I N D E X

Service Bulletin No.

Sea Bee Service News
Republic Aviation Corporation

FIG. 2

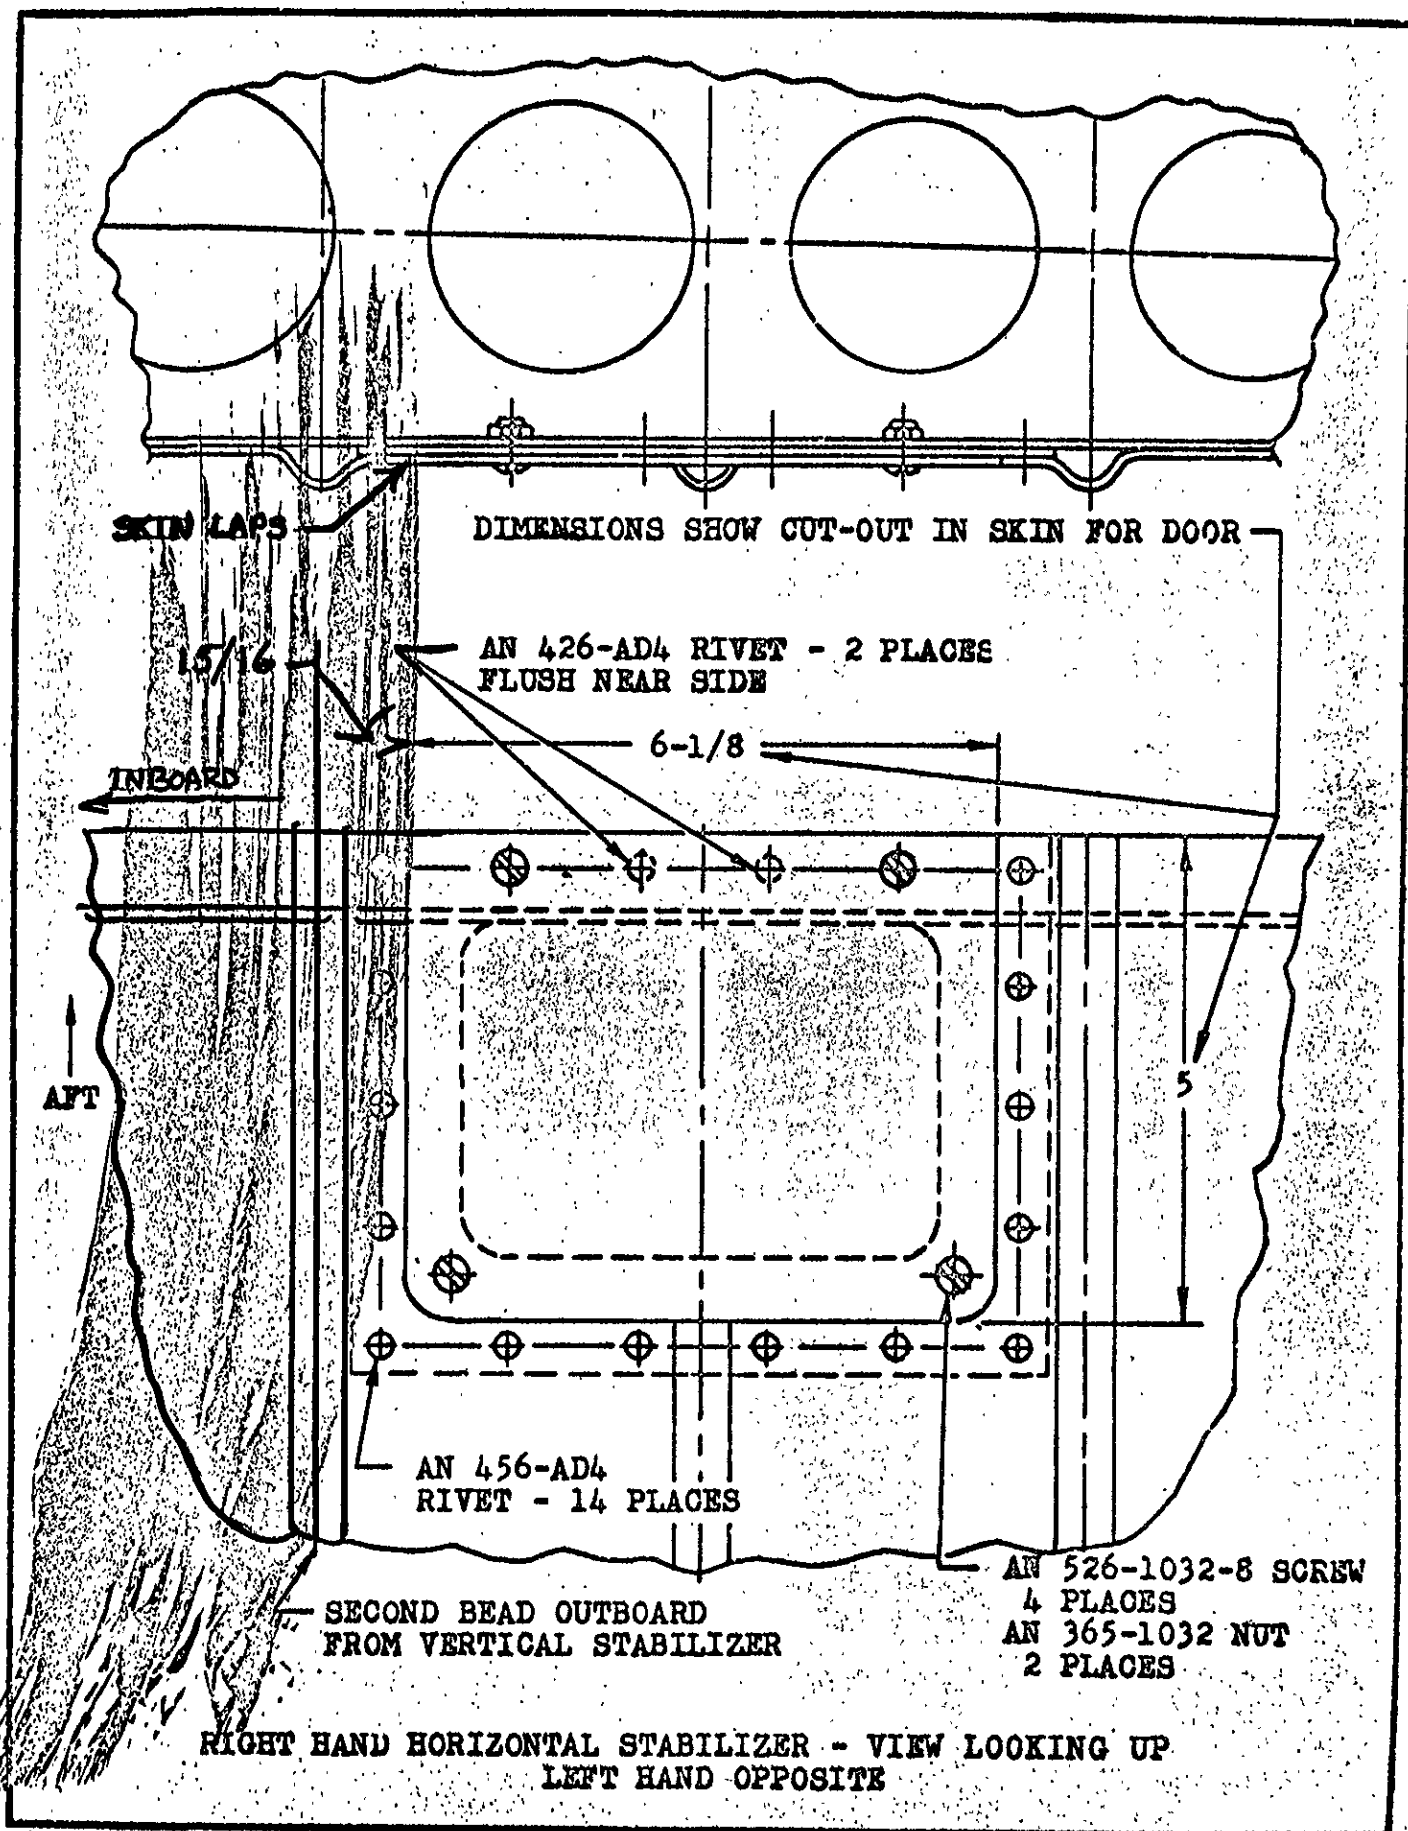
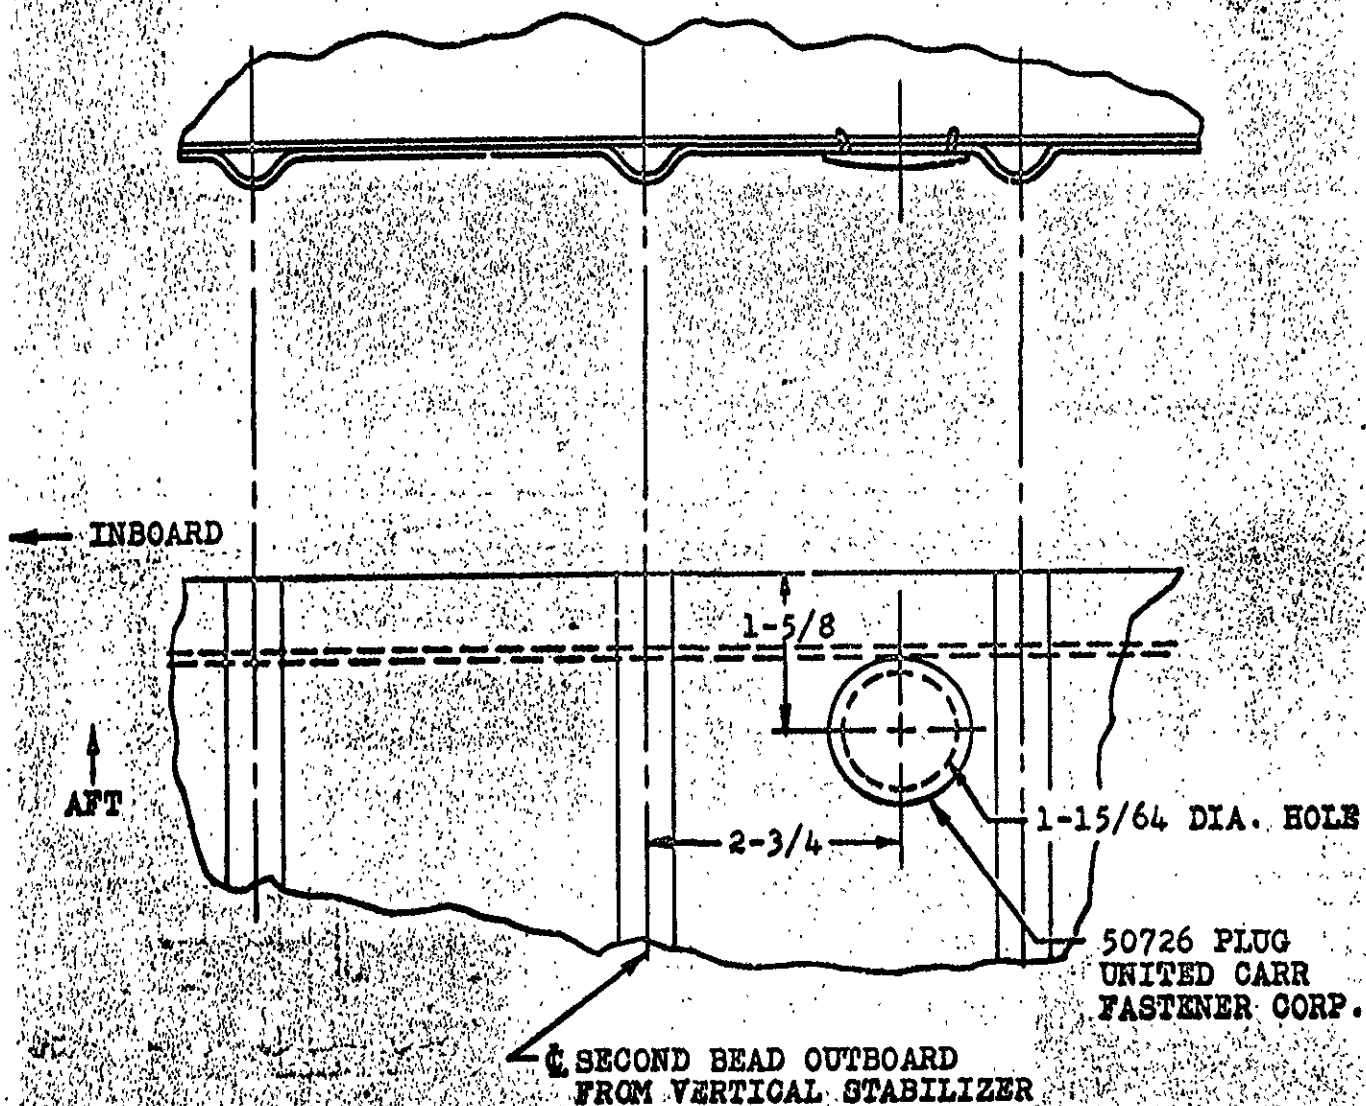
The large handholes require a door and frame for each stabilizer. These may be made in accordance with instructions on Figure 1 and installation of the frame and door may be accomplished as shown on figure 2.

REINFORCEMENT OF AFT CABIN SKINS

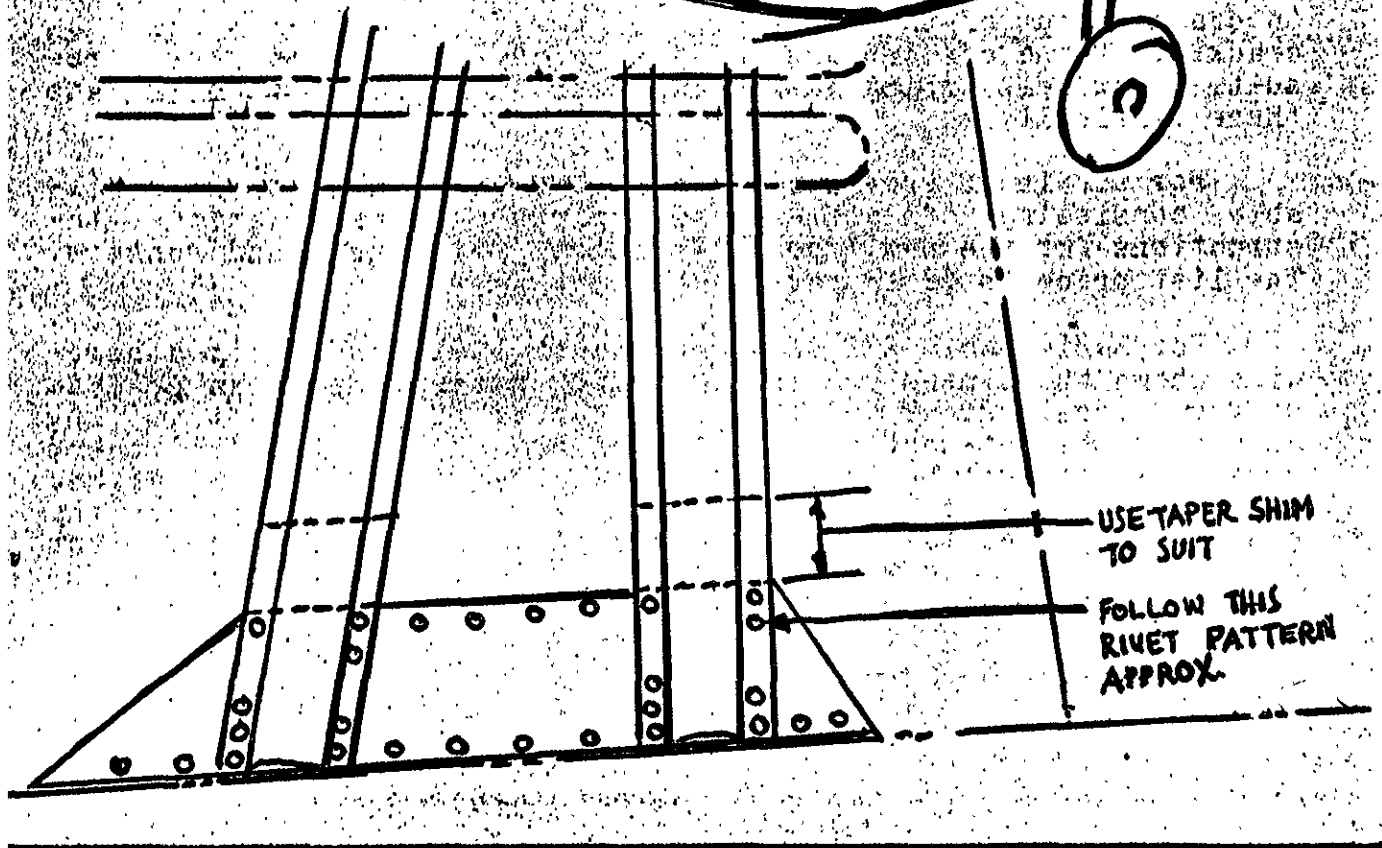
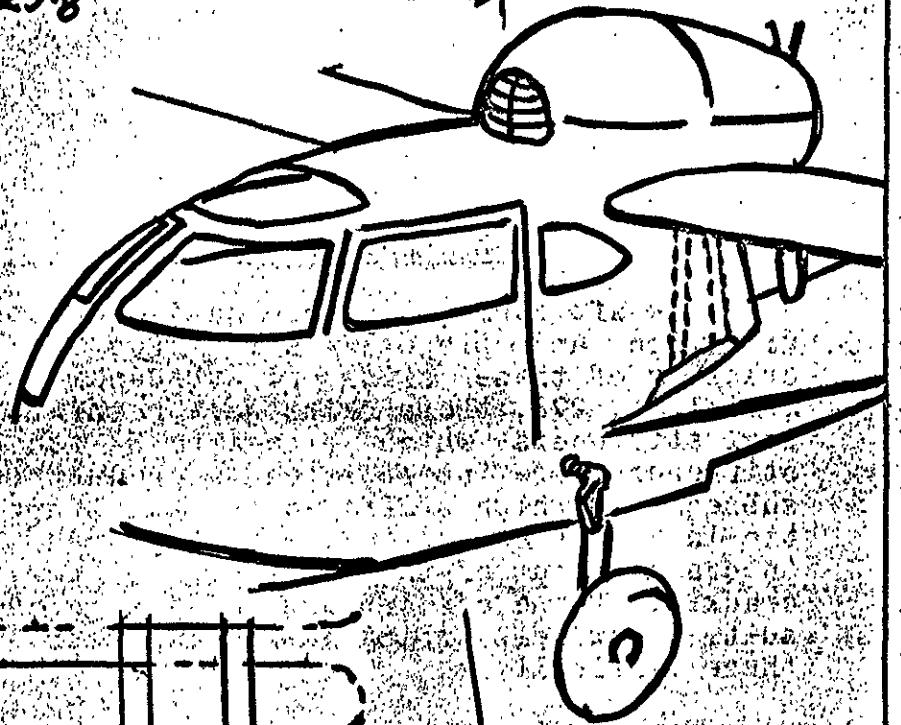
The aft cabin skins are subjected to stresses due to engine vibration and propeller air buffeting which has resulted in cracking of these skins and stiffeners. On Seabees previous to Serial No. 278, these skins were reinforced with Z-section vertical stiffeners which proved to be too light. New hat-section stiffeners were incorporated in production on Serial No. 278 and subsequent which stiffened the skins appreciably. However, the tie-in to the angles to the hull proved insufficient, resulting in cracking out of the lower ends of the stiffeners as well as cracking of the aft cabin skins just above the angles. As a result, a new reinforcing gusset has been developed to eliminate these difficulties.

For airplanes previous to Serial No. 278, a kit is available consisting of all necessary parts and installation instructions for the new type hat-section stiffeners and gussets. The list price is \$8.15 per kit.

View From RH Side
Fig. 3

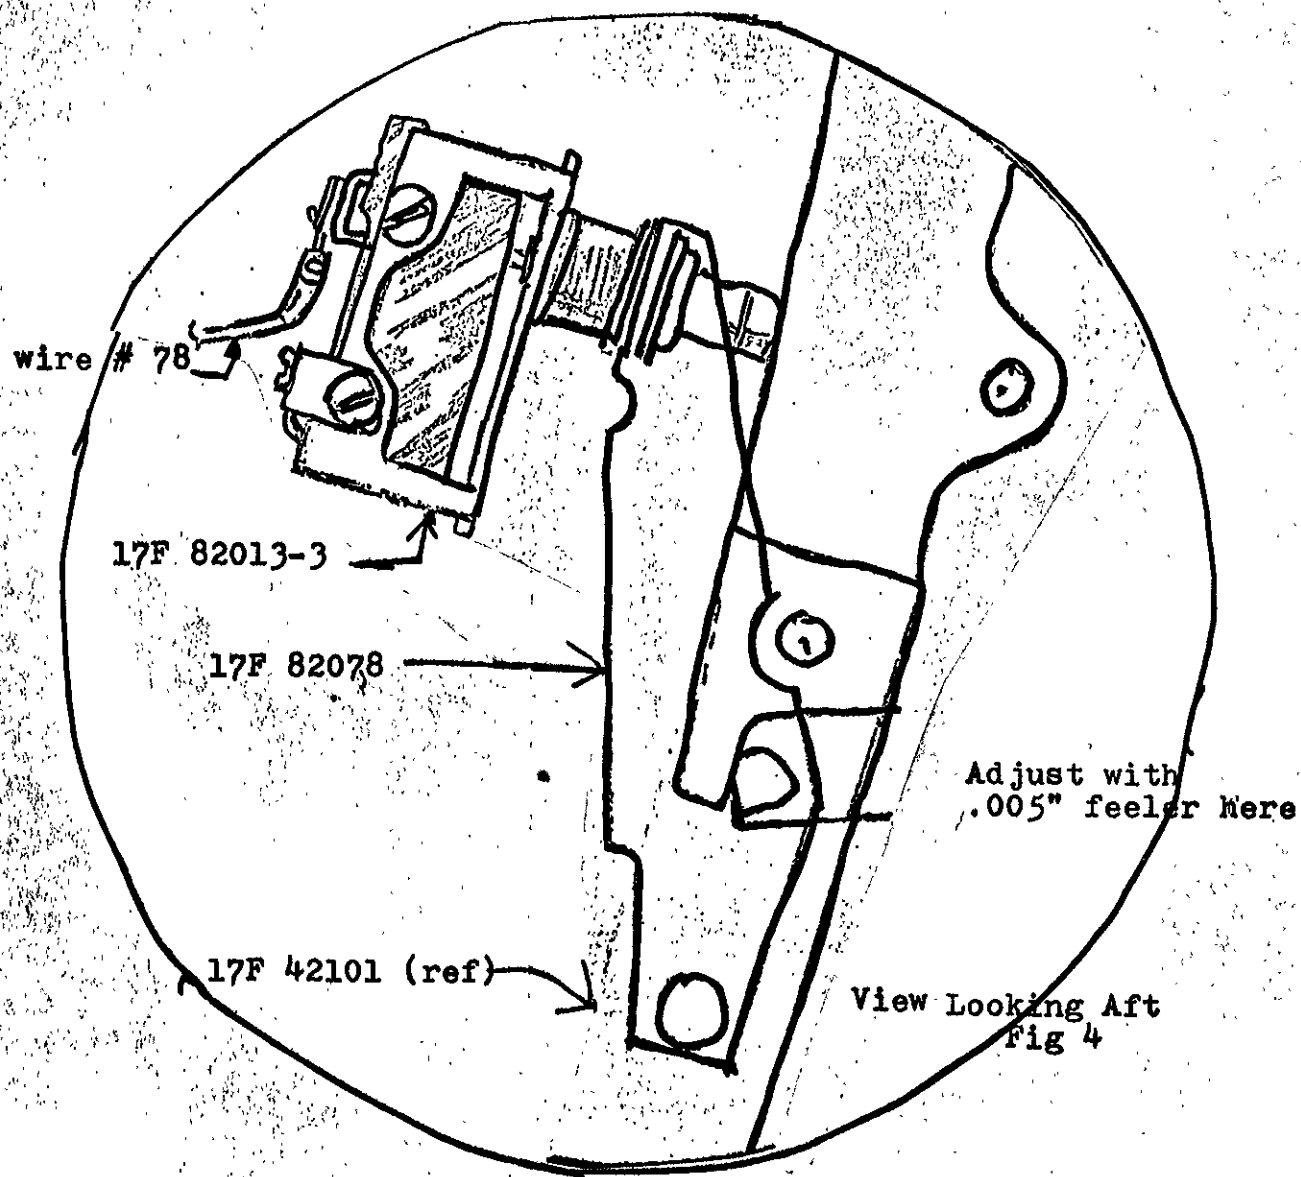
8. Remove the lower tail wheel actuating link assembly 17F42101 and drill out two upper 3/16" rivets, saving the spacers between the links. Use extreme care not to elongate holes. Locate the new tail wheel signal switch bracket 17F82078 on the forward side of the link assembly with the offset to the right and attach with two AN3-11A steel bolts, original bushings between links, AN960-10 washers and AN365-1032 nuts. Refer to figure 3 for bracket installation.

Figure 1

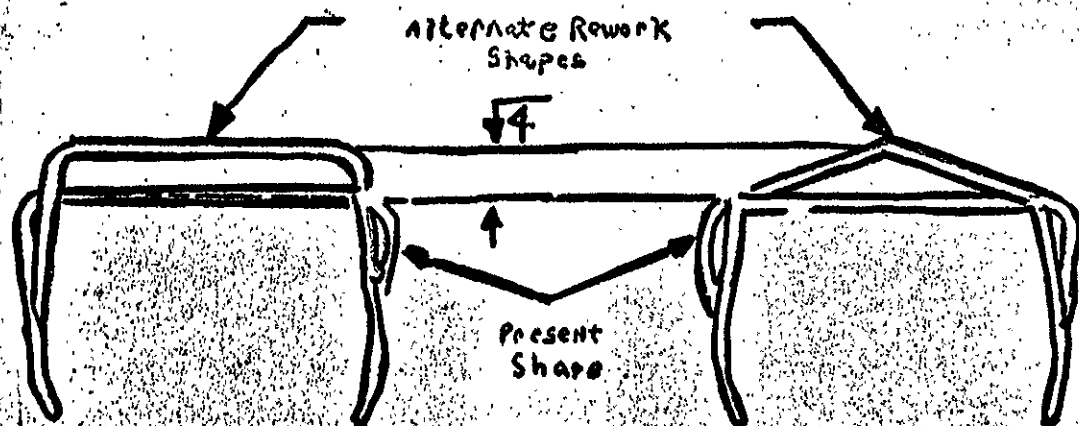
1. Remove top and right hand side cowl.
2. Remove starter terminal junction cover and rework as shown on Figure 1 by bending.
3. Replace junction cover, top and right hand side cowl and make suitable entry in log book.

FIGURE 4

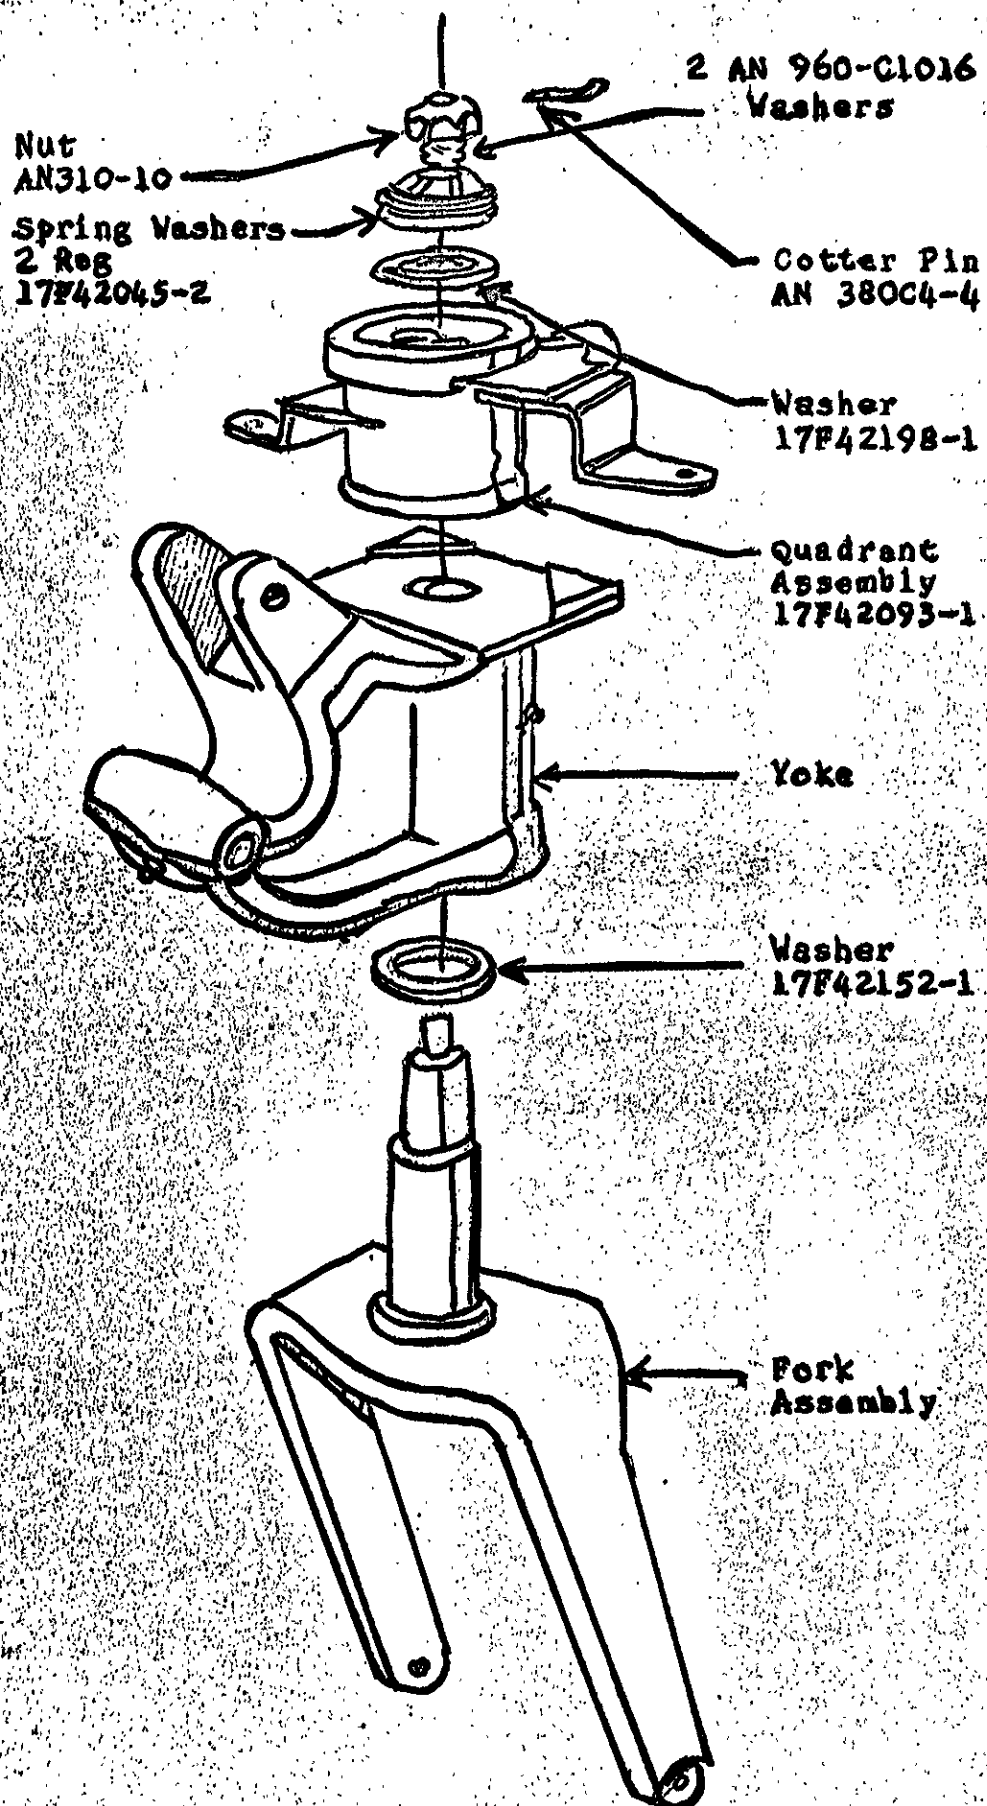
2. Assemble fork on spindle using two NAS143-24 washers, AN7502-24 nut and AN380-5-10 cotter pin as shown on Figure 4. This nut must be torqued as tightly as possible (3000 inch lbs. min.) Do not back off to obtain cotter pin hole alignment.
